# SERVICE BULLETIN No.1109

<b>COACH MODEL</b>	: T&S 2100 Series
<b>BULLETIN TYPE</b>	: Product Improvement
<b>MANUAL &amp; SECTION</b>	: Maintenance Manual: Chapter 10 - HVAC System Spare Parts Manual: Section 738109 – Front bumper
<b>PARTS BOOK REVISION</b>	: No
<b>DATE</b>	: September 12th, 2002
<b>SUBJECT</b>	: <b>Front unit air filter</b>
<b>TERMS &amp; CONDITIONS</b>	: No claims will be accepted with reference to this Bulletin.

**Figure 1: Old straight pull rod and trapezoidal mounting brackets. Rod length: 4ft 1-31/32 inch**

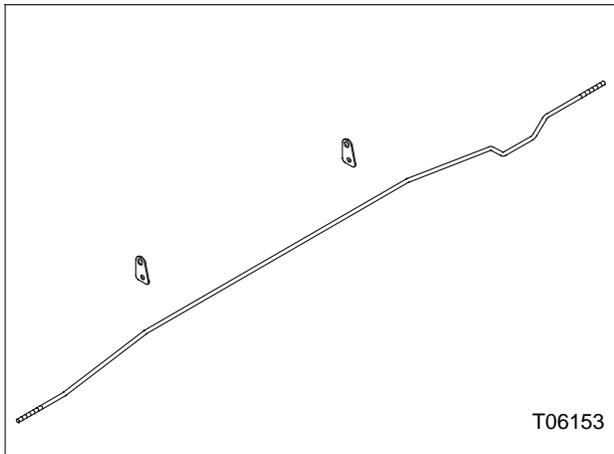
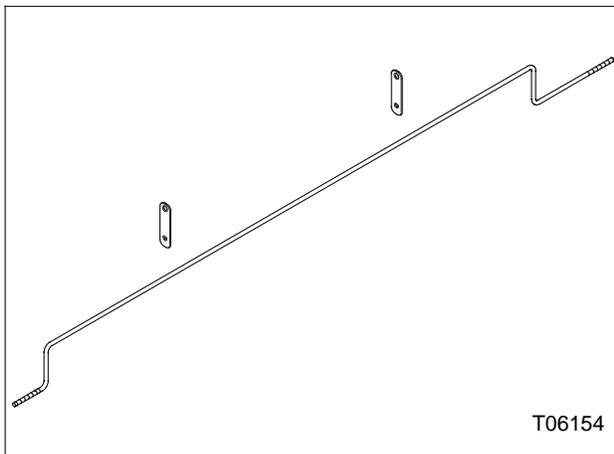
The T2100 and S2100 Maintenance Schedule instructs coach owners to have the HVAC air filters checked and cleaned every 6,000 miles, or more frequently if necessary. The access to the driver's climate unit air filter on earlier coaches with rubber sprung front bumpers is hampered by the bumper pull rod. Checking and cleaning the filter requires removal of the bumper pull rod every time the filter is serviced. To remedy this issue, a modified pull rod and suitable mounting brackets have been introduced into production as from the above-mentioned units.

The procedure in this Bulletin shows how to replace the old pull rod by the new.

**Figure 2: New stepped pull rod and oblong mounting brackets. Rod length: 4 ft**

- Part numbers remain unchanged. To modify one coach, order one pull rod VH 10703079 and two brackets VH 10703117.
- Old and new parts are interchangeable, but only the new will be offered as service replacements.
- Parts may be purchased from your nearest ABC Companies Parts Source dealer.
- Always use genuine maintenance products and parts. Do not accept imitations.
- Parts disposition: discard according to applicable environmental regulations.

**Figure 1: Pull rod and sliding bracket**

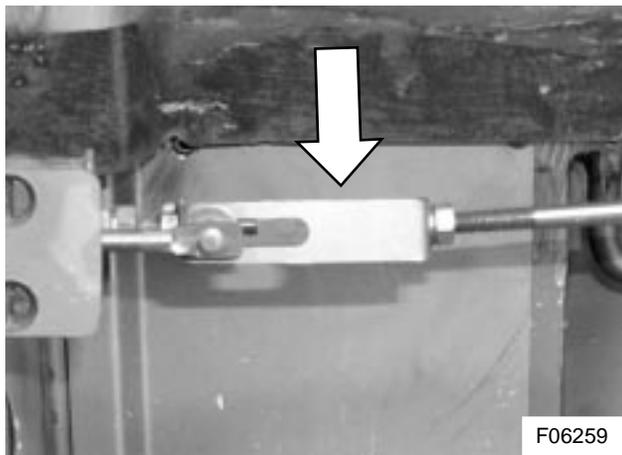
- 1) Lower the front bumper.
- 2) At the driver's climate unit undo and remove the two M5 bolts securing the pull rod mounting brackets to the unit housing.
- 3) At the bumper latches undo and remove the nuts and washers securing the pull rod to the sliding brackets (see Figure 1).

**Figure 2: Pull rod mounting brackets flush with filter cover**

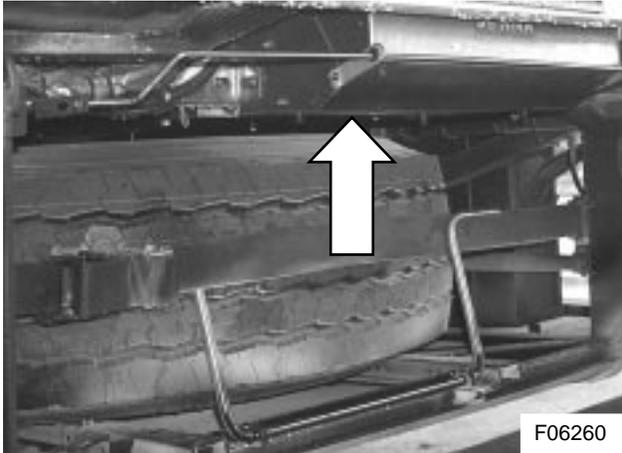
- 1) Installation is the reverse to removal.
- 2) Recover the rubber grommets from the old brackets and install them in the new.
- 3) Make sure to install the mounting brackets in line with the filter cover (see Figure 2).

- 4) Tighten the mounting bracket bolts to a torque of 5 ft.lbf (7 Nm).
- 5) Pull the quick release pins securing the filter access door. Check door operation (see Figure 3). Remove and clean the dry filter element as explained in Section 10.4 of the Maintenance Manual. Refit the filter and close the access door.
